**AGENDA FOR REGULAR MEETING  
VILLAGE OF TINLEY PARK  
PLAN COMMISSION**

**Item #1      PUBLIC HEARING: LENNY’S FOOD N FUEL 183RD STREET, LLC  
7451 183<sup>rd</sup> STREET**

# PLAN COMMISSION STAFF REPORT

**Changes to the November 7, 2019 Workshop Staff Report are indicated in Red. Renderings, Architecture, Site Plan and Landscape Plan were updated.**

## SITE PLAN

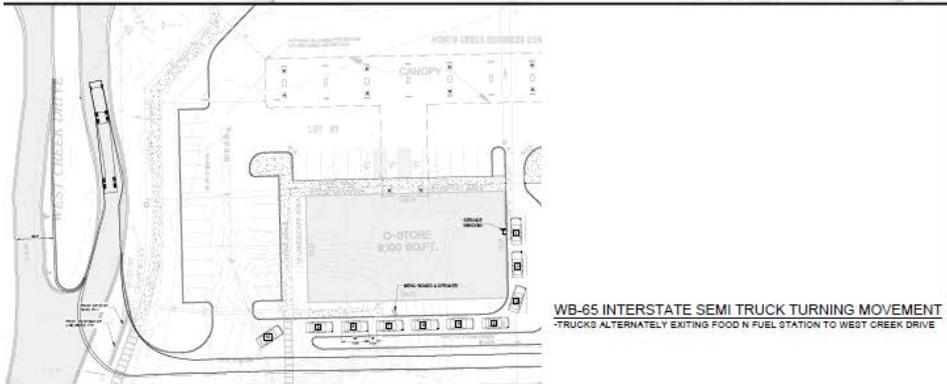
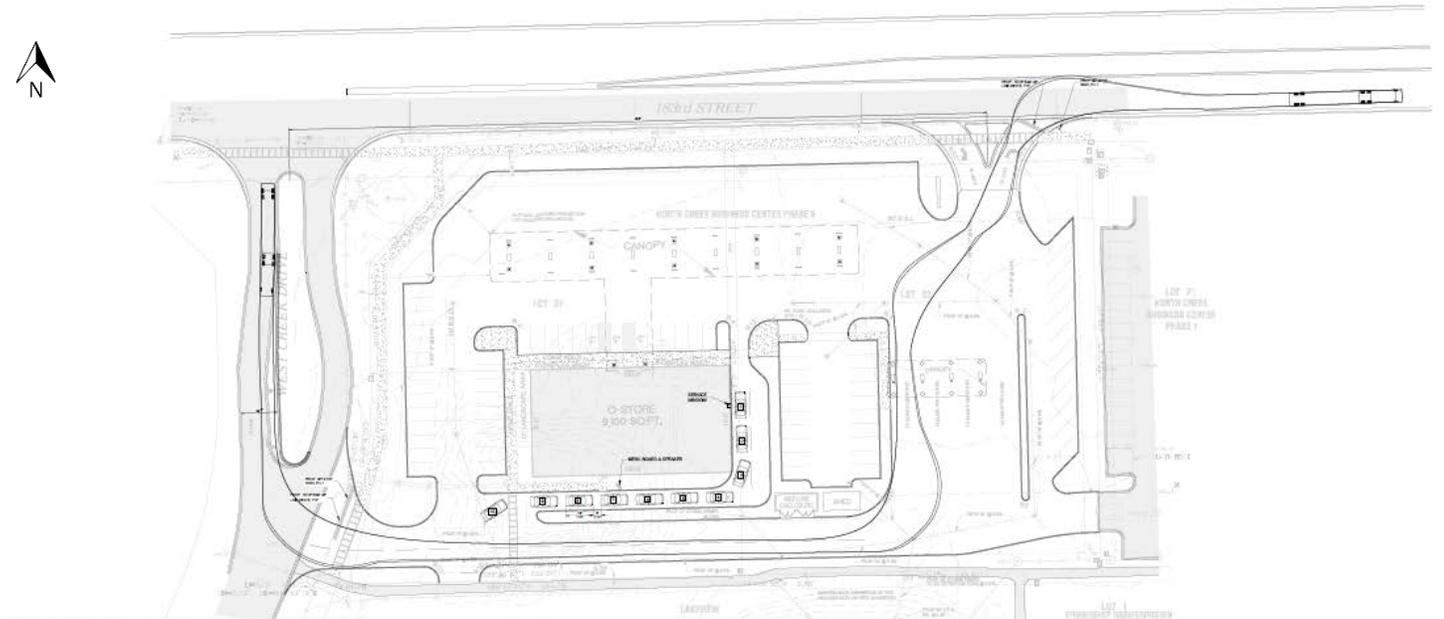
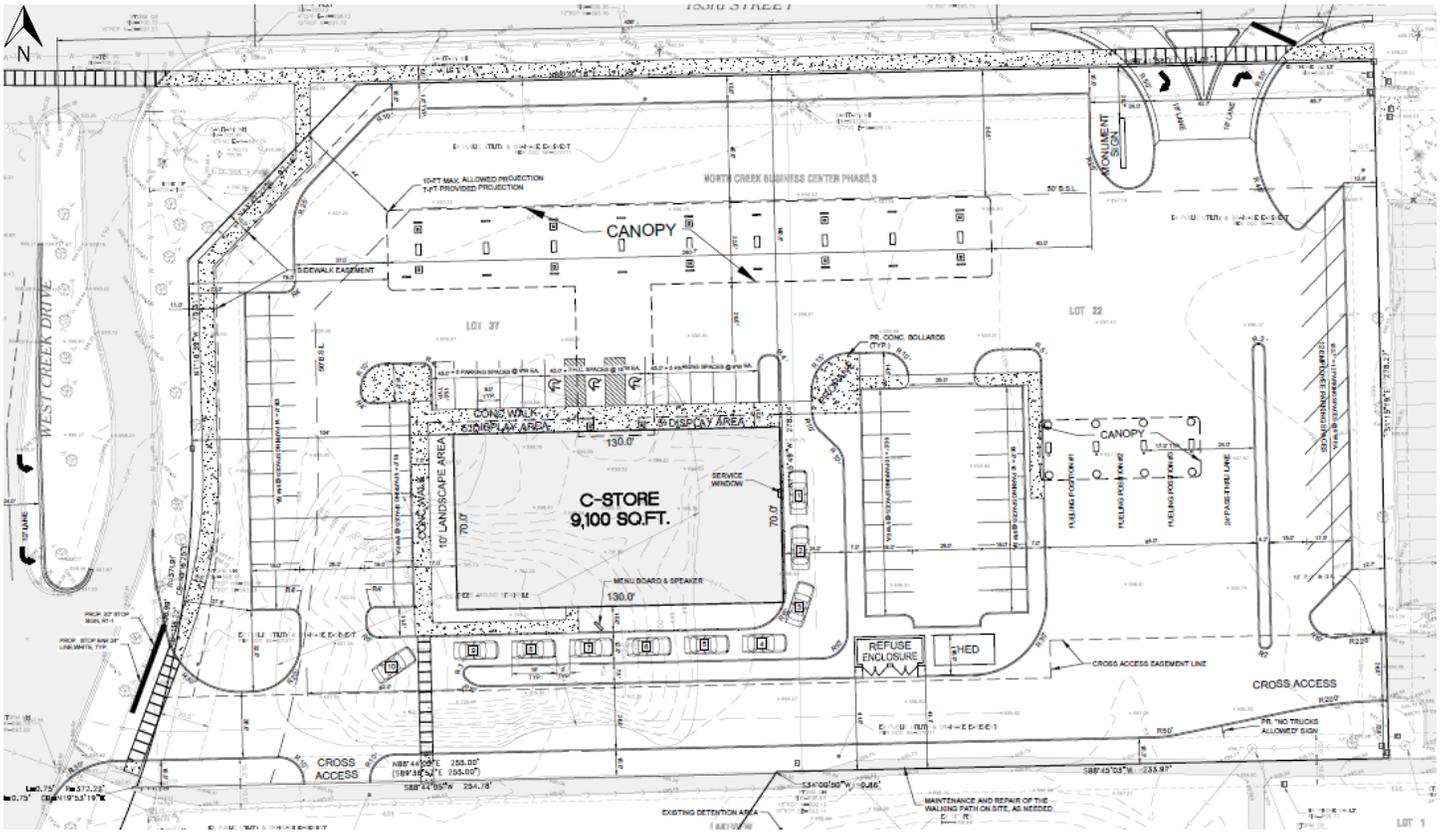
The plans have been revised to show right-in/right-out access along 183<sup>rd</sup> Street that is expected to be more efficient and safer for turns in and out of the site. The access will have a raised median and signage as required by Cook County DOT to ensure the right-in/right-out requirement is being followed. Full-access will still be available through West Creek Drive and North Creek Drive.

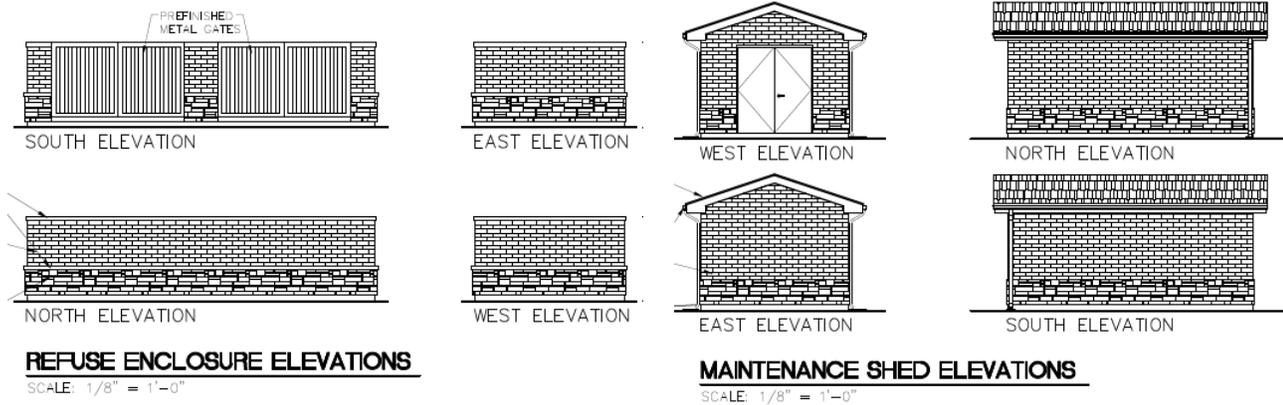
The second waiver being requested is in regards to the interior parking lot landscaping. The petitioner has worked to offset these deficiencies by meeting the high density and size of landscaping required throughout the site perimeter. The landscape code is not particularly easy to comply with on a gas station property in regards to interior parking lot landscaping. The fueling area needs to remain free from obstructions and allow room for vehicle and truck movement throughout the site. Landscaping pots can be added but these are often hard to maintain hearty landscaping in throughout the year.

The interior landscaping shortage is a result of the gas station fueling area being counted as a parking lot. The Plan Commission agreed there was limited ability to expand this landscaping without creating vehicle safety or maintenance issues.

### RENDERINGS

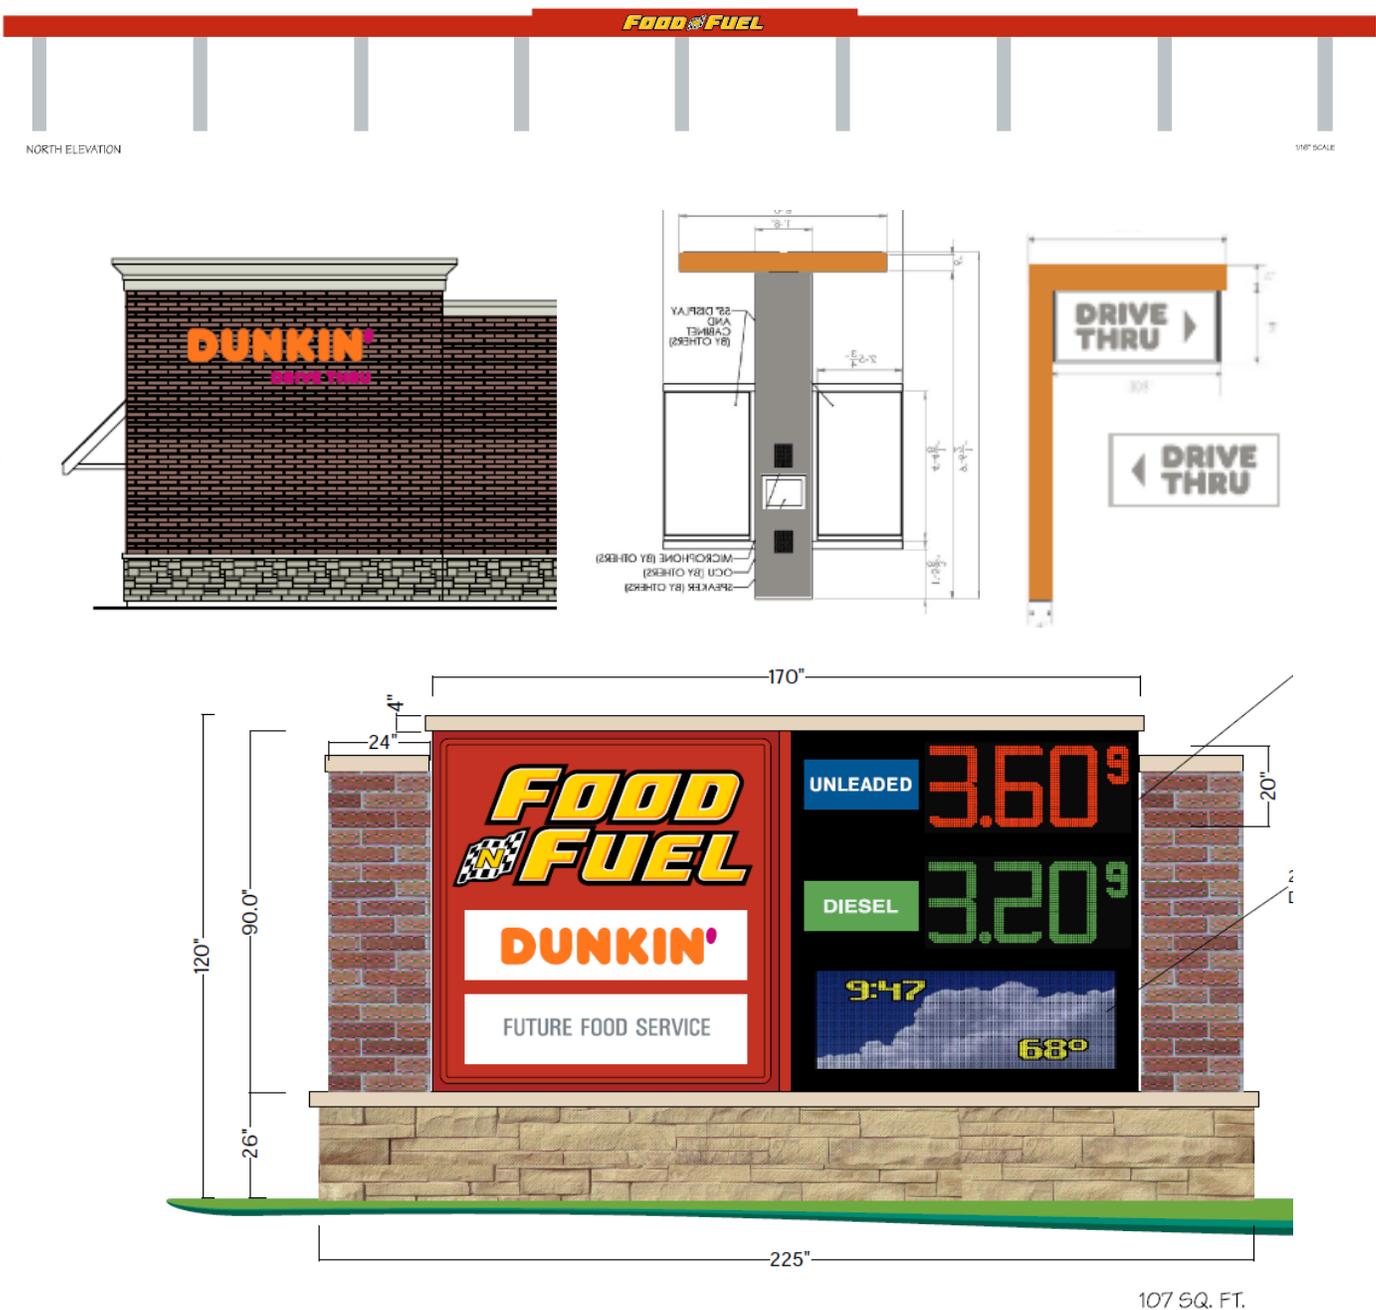
The renderings were revised with the changes from the staff report and Plan Commission workshop, with the exception of the brick on the front façade of the convenience store.
